MID-MICHIGAN DISTRICT HEALTH DEPARTMENT

SEWAGE DISPOSAL SYSTEM EVALUATION REPORT

APPLICATION NUMBER: L-59-00-019

PROPERTY LOCATION: 21757 Oak Dr.

5. Please provide a simple sketch below showing the general location of the septic tank system in relation to the house, garage, road, or other features of the property. Include DISTANCES and DIMENSIONS if possible.

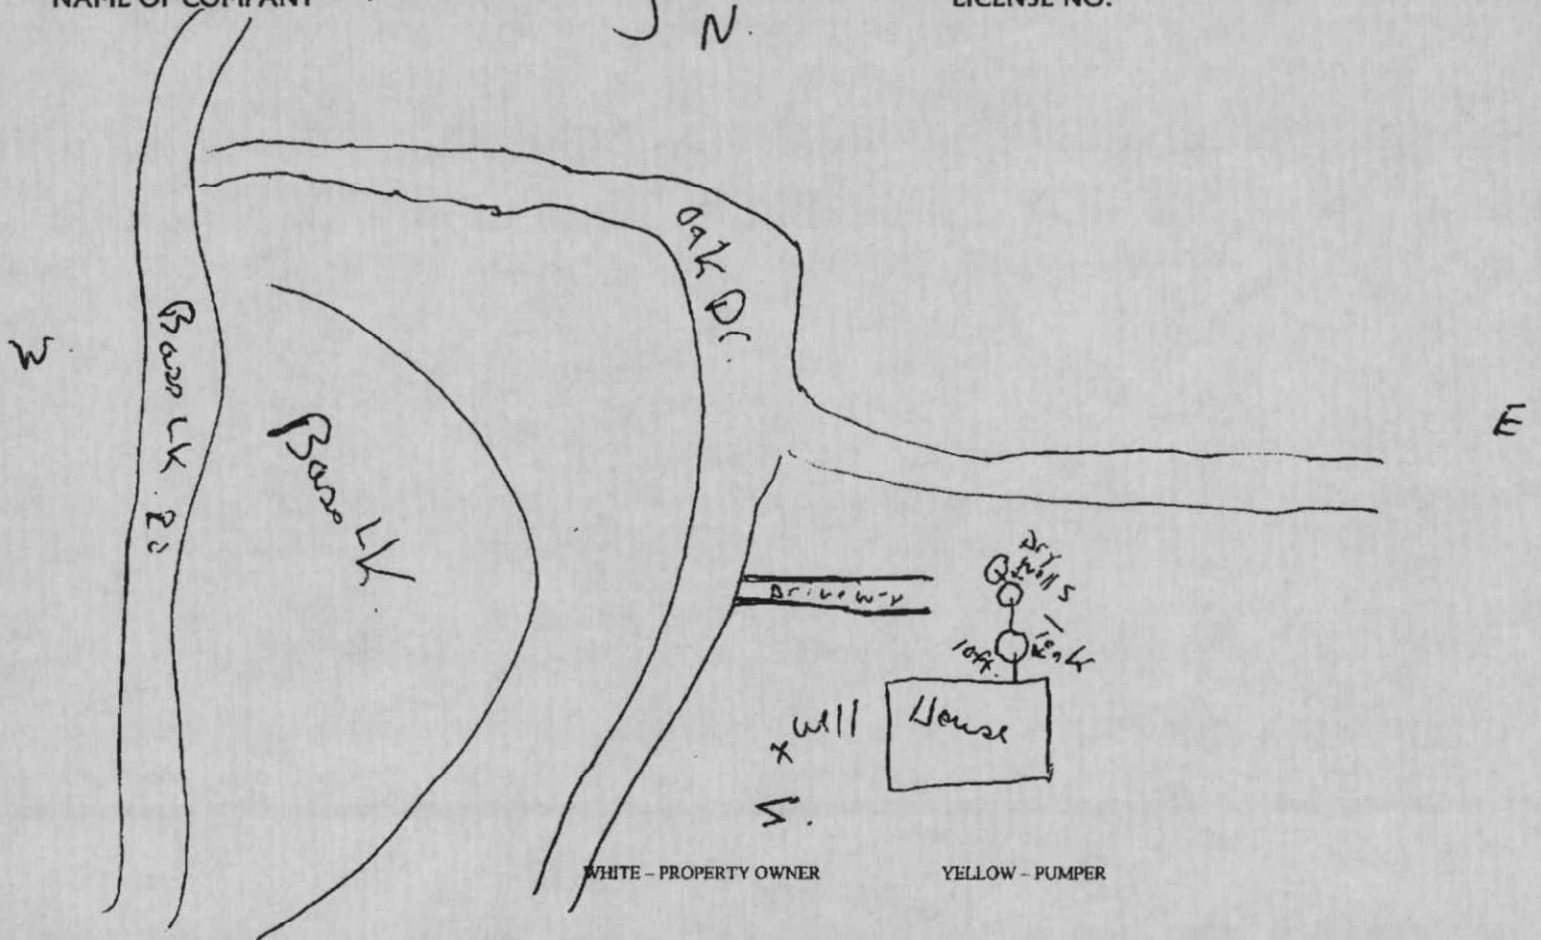
IF YES, EXPLAIN Water was running back from drywells in to septic tank. ~~Could not see baffle in tank opening so to speak.~~

Type of System: Drywell

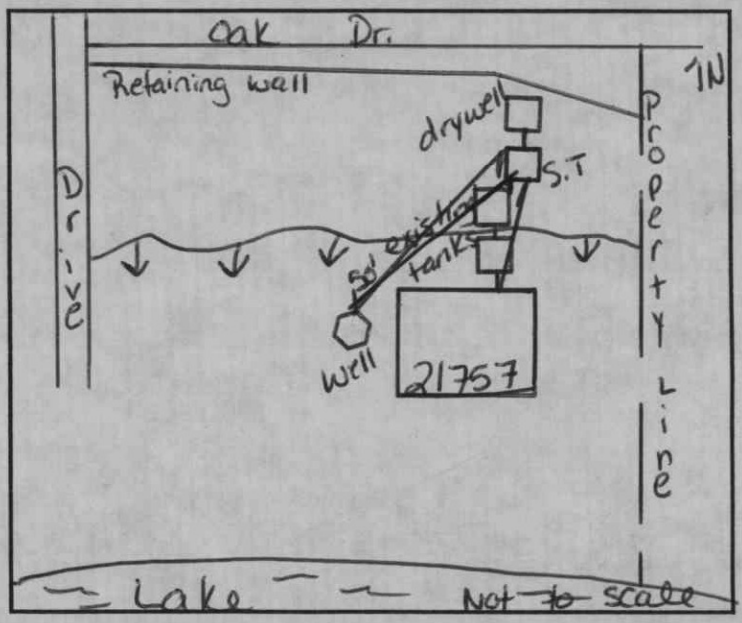
ADDITIONAL REQUIREMENTS:
Require a 1000 gallon septic tank w/ effluent filter, & a 1000 gallon drywell. Place a riser on both septic tank and dry well if deeper than 24" below original grade. Pump, crush, & fill old tanks. Maintain all minimum isolation distances stated.

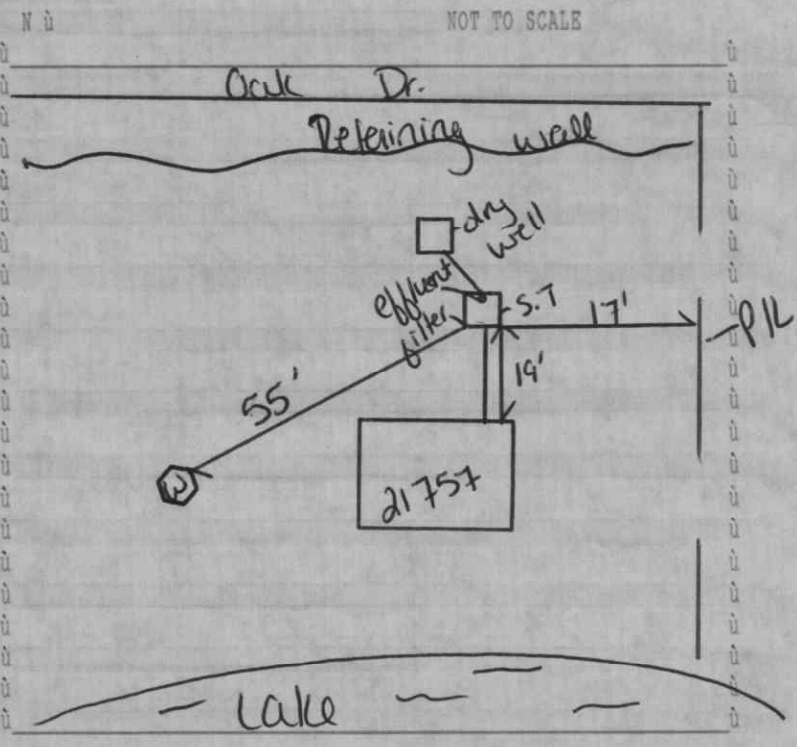
COMMENTS: OLD TANKS PUMPED CRUSHED AND FILLED. DRYWELL INSTALLED PROPERLY.

Site Drawing: (Not to Scale)

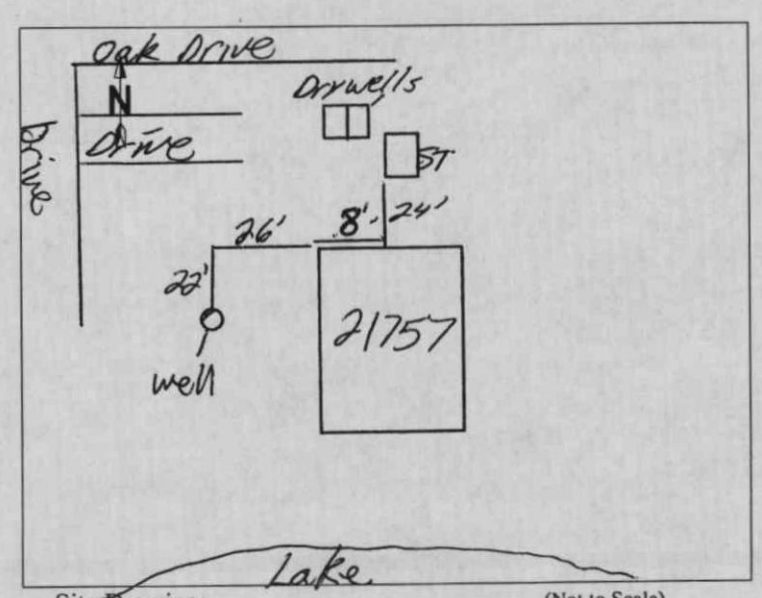
Additional Comments: Septic system was installed in 2001. The system is composed of a 1000 gallon septic tank and 2 – 600 gallon drywells for drainage. The septic system was approved and properly permitted. The well does not have a well log on file but a permit was written for the installation of the new well. The water samples are satisfactory with no bacteria in the water and also no nitrates detected. The well construction meets all codes and regulations. All aspects of the septic disposal system and the well water system appeared to be in proper working condition during the inspection.
